ADDENDUM TO REQUEST FOR PROPOSAL DOCUMENT
FOR
Moosomin Dam
Service Contract No. 5
Dam Safety Review
REQUEST FOR PROPOSAL # 4547:928-7P11-0-S1-5

Addendum No. 3

Q&A:

PIPESTONE CREEK (MOOSOMIN DAM) PROJECT			
GENERAL PLAN AND RIPARIAN CONDUIT DETAILS			
Scale As Shown	Date June 2003	Sheet 1 of 1	207598

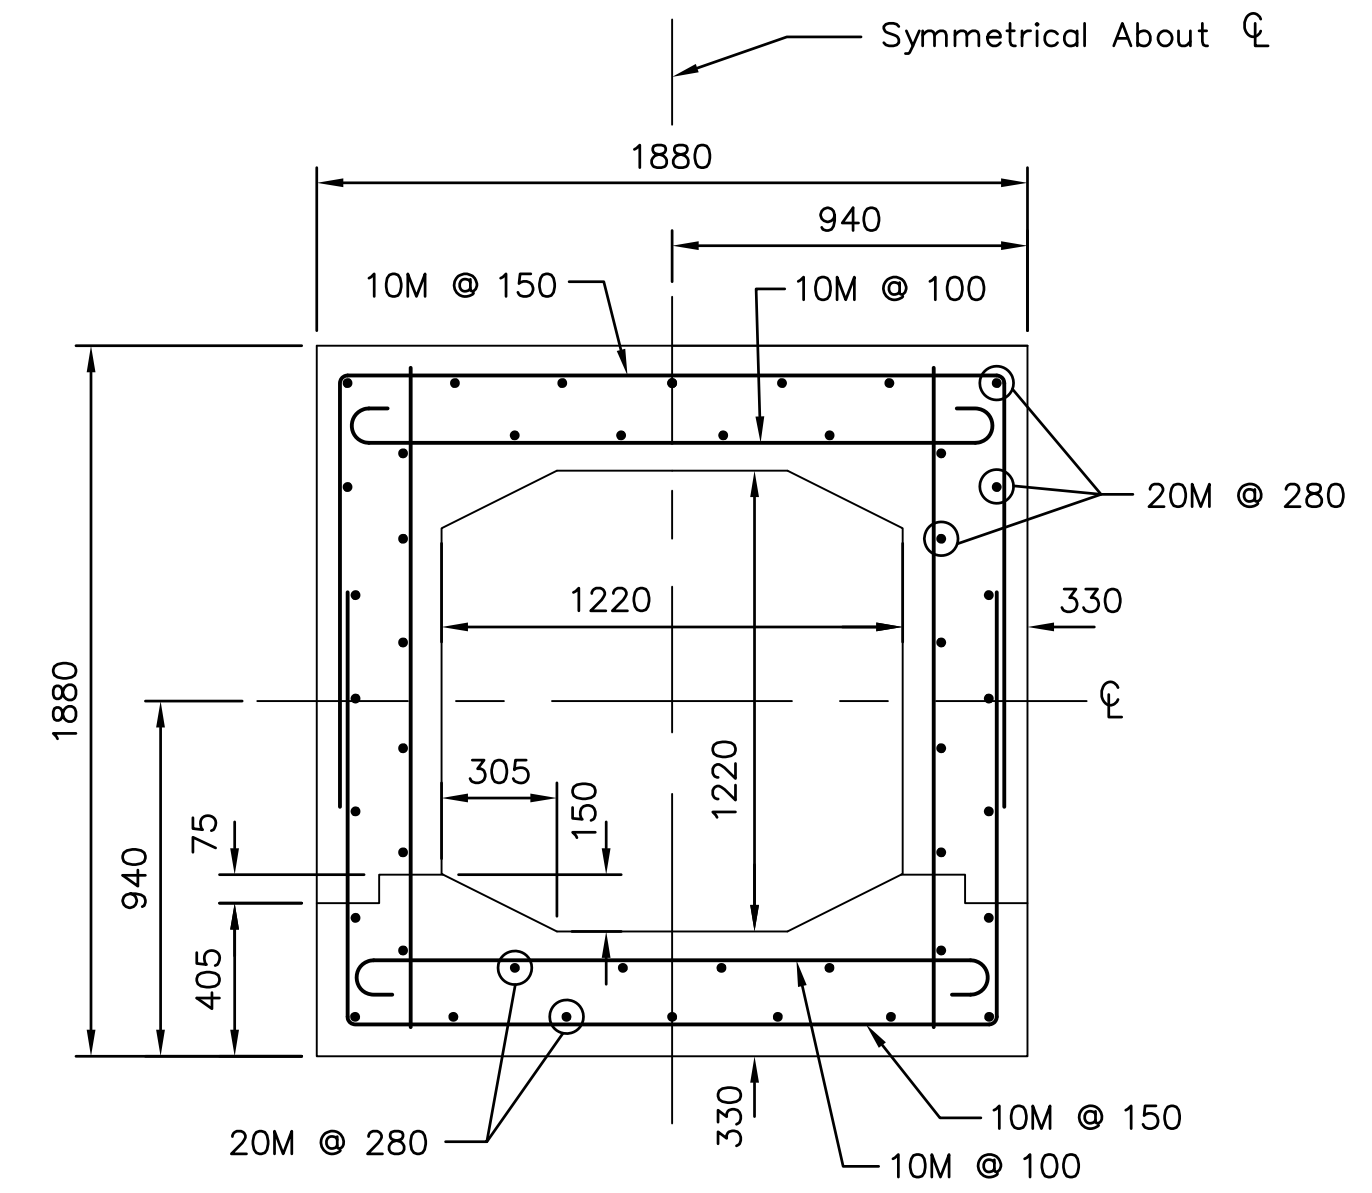
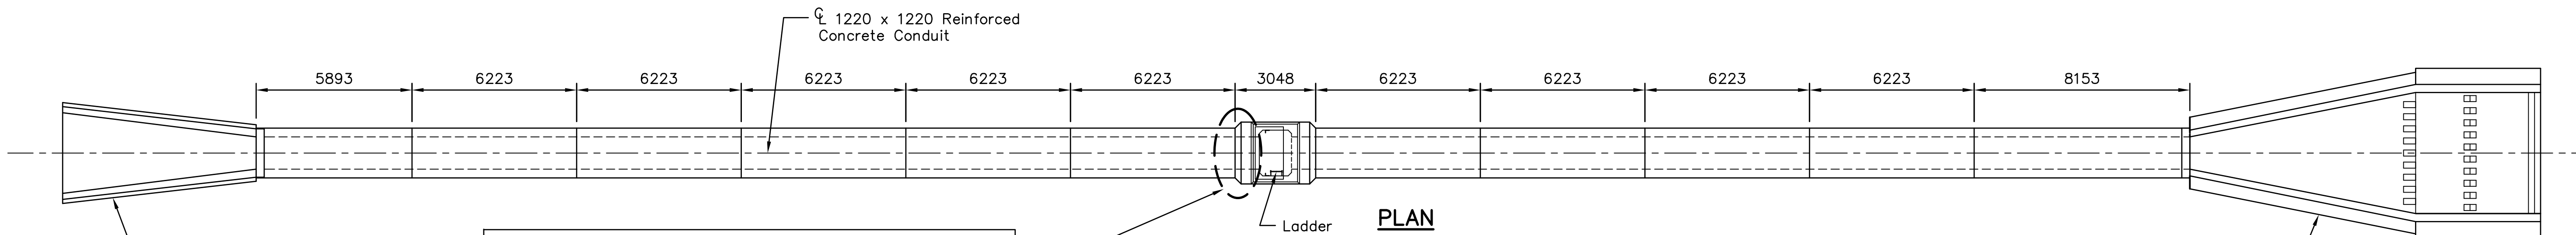
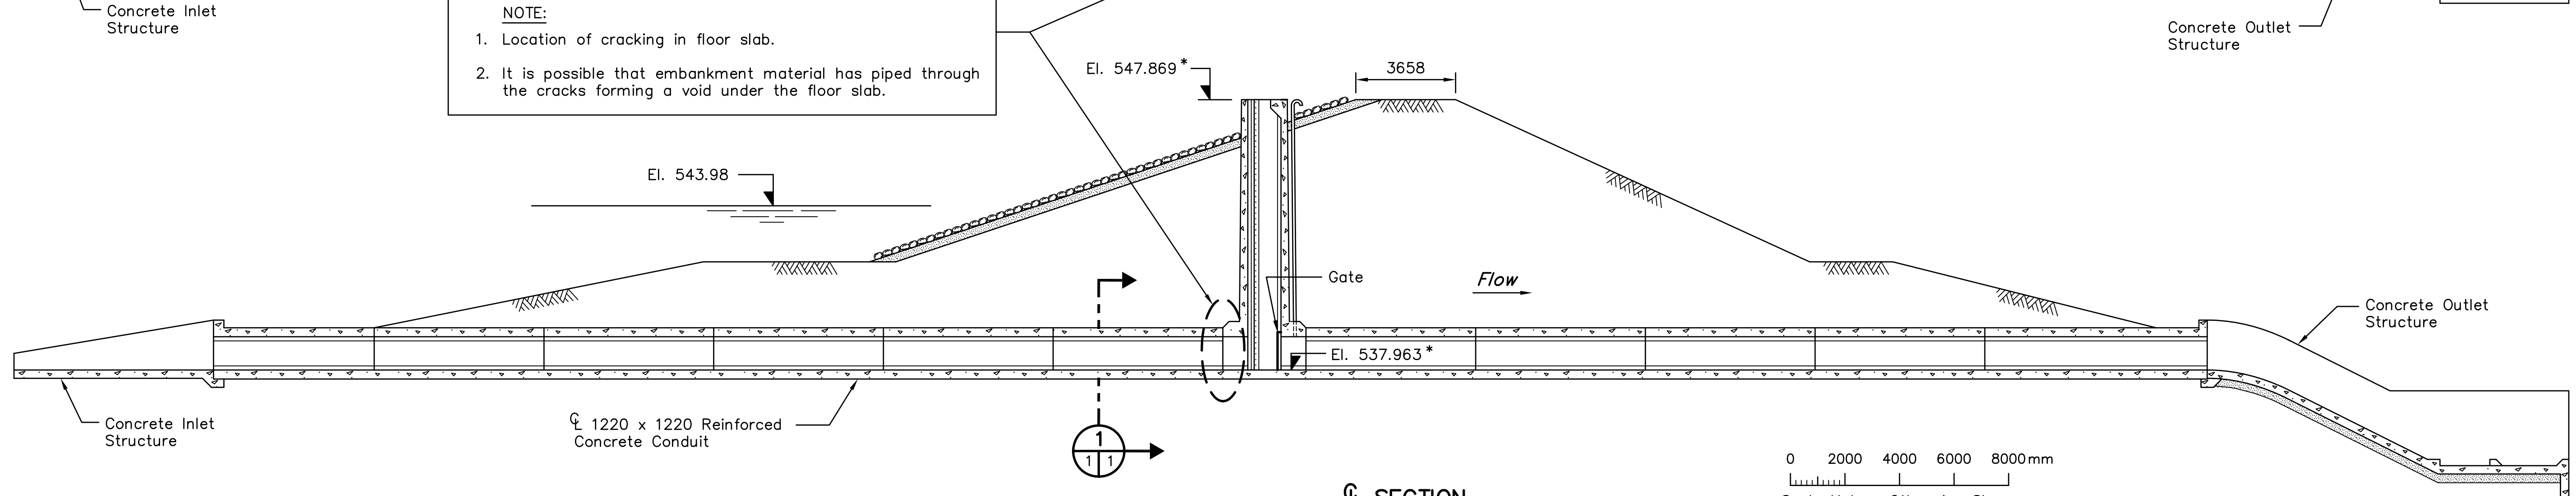
Q2 - We would like to confirm the inside dimensions of the riparian outlet conduits. The documents make reference to 1.2m square conduit. Could you please confirm this is the case for both up and downstream?

A2 - Both the upstream and downstream conduits are 1.2m square conduits. See attached drawing.
